# Authorized Field Change

**AFC G-04904**

**Subject:** Fan Blade to Fan Shroud Contact in 5500i and 5600i Models Built Between November 1, 2002 and March 31, 2004 with Post 2004 Cummins and Caterpillar Emission Engines

**Figure 4 Fan Shroud to be Modified Between Arrows**

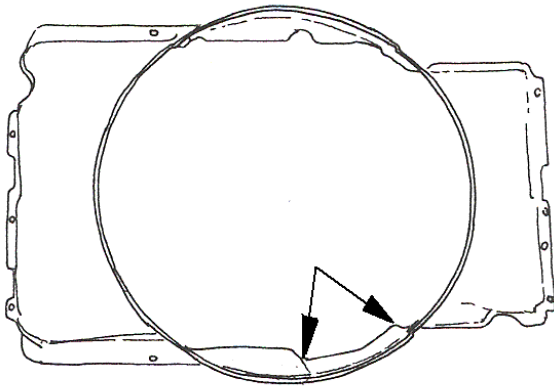
Certain 5500i and 5600i Models built between November 1, 2002 and March 31, 2004 with Post 2004 Cummins and Caterpillar Emission Engines may have fan blade to fan shroud contact due to insufficient clearance at the lower right (passenger) side of the shroud. Modifying the fan shroud will prevent fan contact.

5. Remove six (6) fan to hub mounting bolts and remove the fan.
6. Remove six (6) fan shroud mounting bolts and remove the fan shroud.
7. Lay the fan shroud on a clean level surface (Figure 4). Arrows indicate the area to be modified.

**Figure 5 Mark Fan Shroud Area to be Removed**

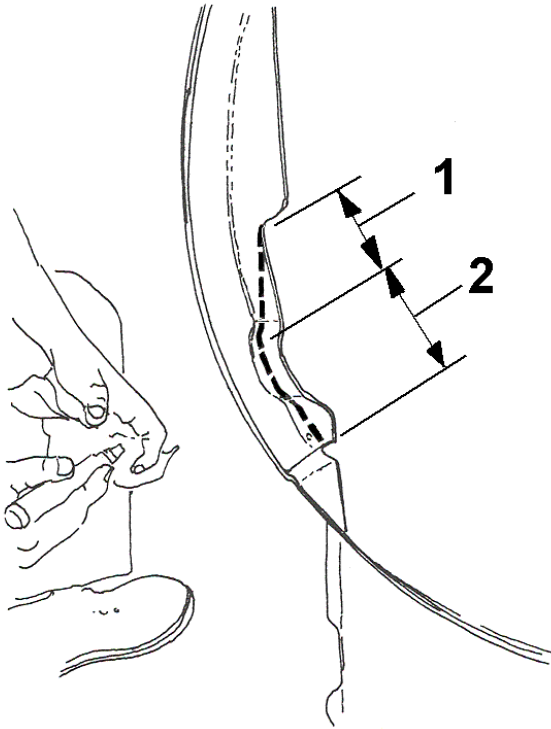
8. Mark a line starting at the right end edge to midway (approximately 5 1/2 inches) on the curve (Figure 5) . Keep the line approximately parallel to the outside diameter of the shroud (Figure 5). Continue marking the line at an angle (approximately 5 inches) to blend with the radius in the left corner (Figure 5).

1. 5 Inches
2. 5 1/2 Inches

**Figure 6 Remove Area with Cutting Tool**

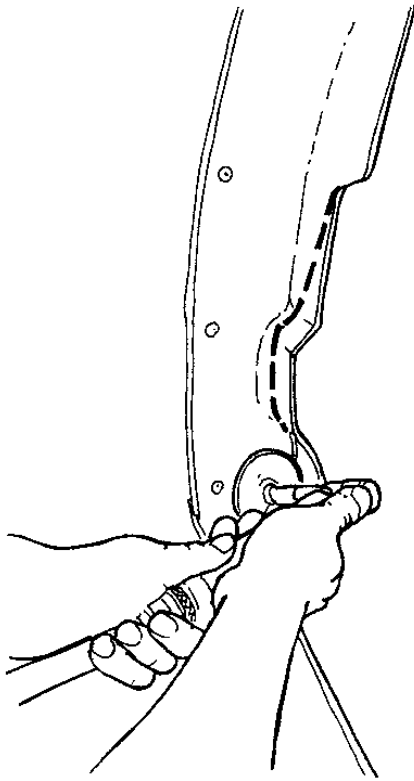
9. With a suitable cutting tool (Figure 6) remove the marked area from the shroud (Figure 7). Clean the shroud of any cutting debris.

**Figure 8 Install "S" Clip**

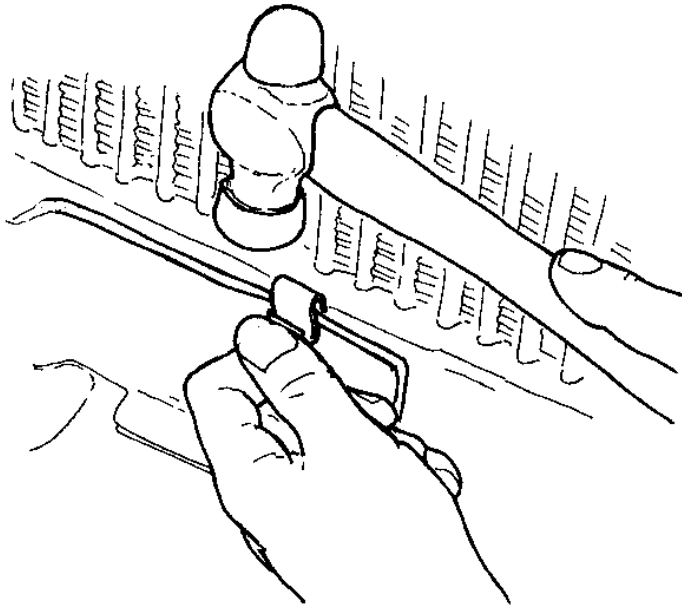
10. Install the narrow opening of the "S" clip, from Kit 2588027C91, on the lower radiator frame 1 1/2 inches from the right edge on the passenger side of the vehicle (Figure 8).

**Figure 9 Verify Modified Fan Shroud Engages "S" Clip**

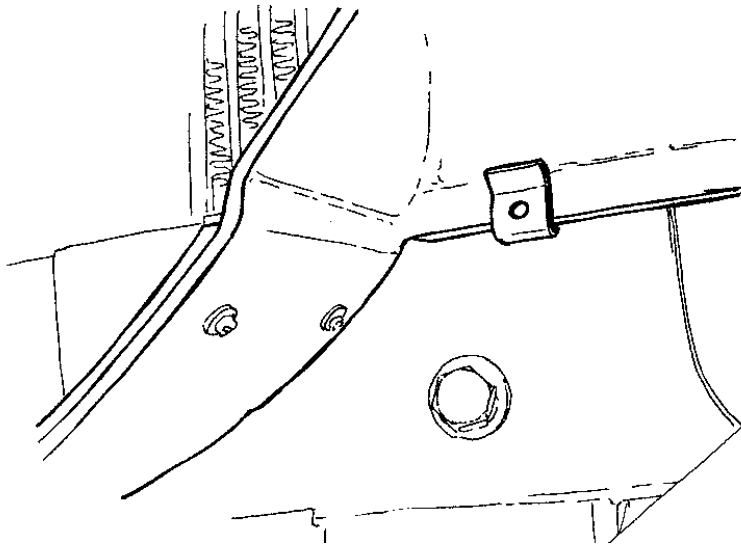
11. Reinstall the modified shroud making sure the bottom edge is seated into the "S" clip (Figure 9). Tighten the mounting bolts to 15 to 19 Lbf-ft (20 to 26 Nm).
